END OF ADDENDUM NUMBER NO. 3

VETERANS AFFAIRS CANADA (VAC) FIT-UP
Saskatoon, Saskatchewan
Suite 501B 101 22nd Street East

VAC Fit-Up – Phase 2

ADDENDUM NO. M-02

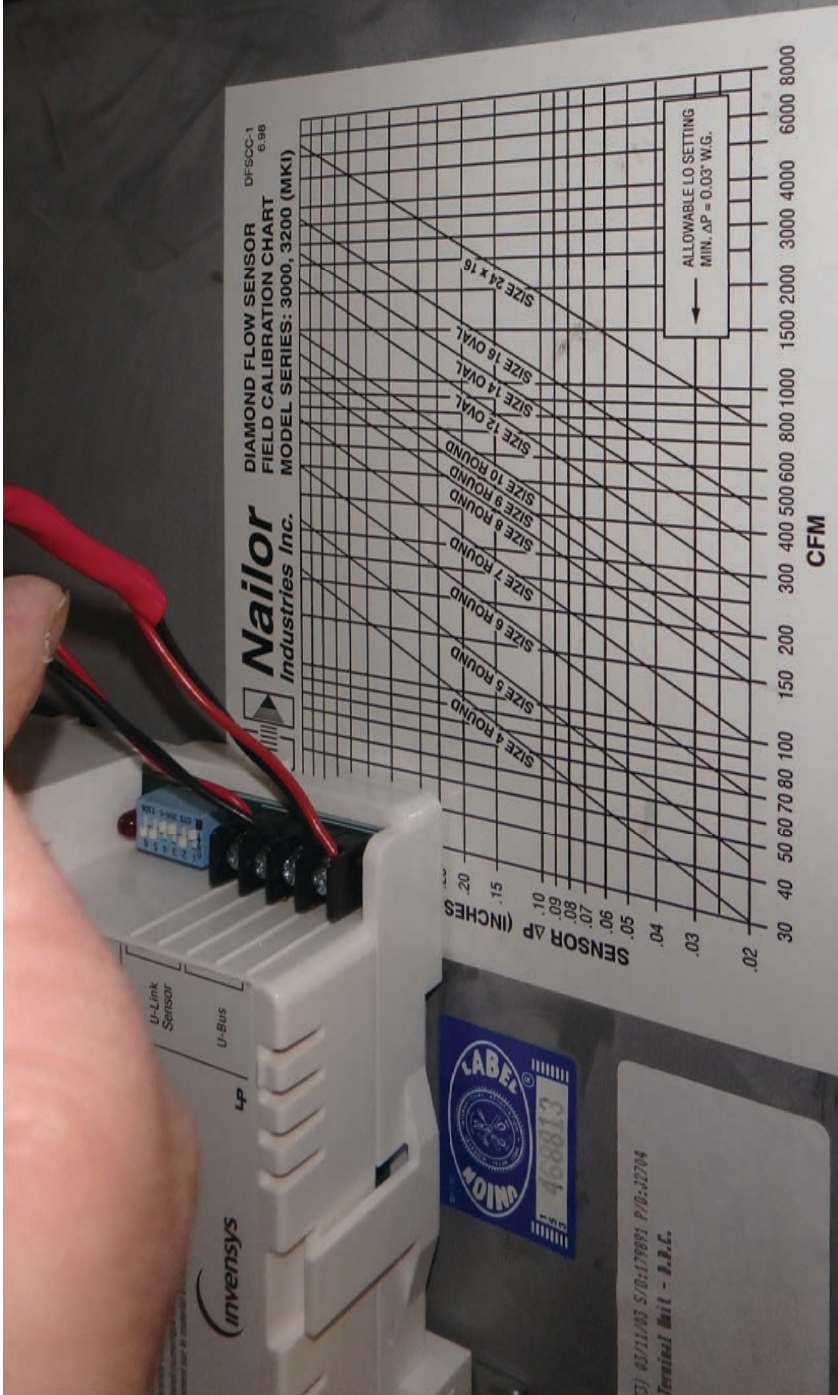
- .1 Refer to attached photos. The area of renovation currently has two brands of variable air volume boxes, EH Price and Nailor. Either are acceptable. Also attached for reference are photos of terminal unit controllers.
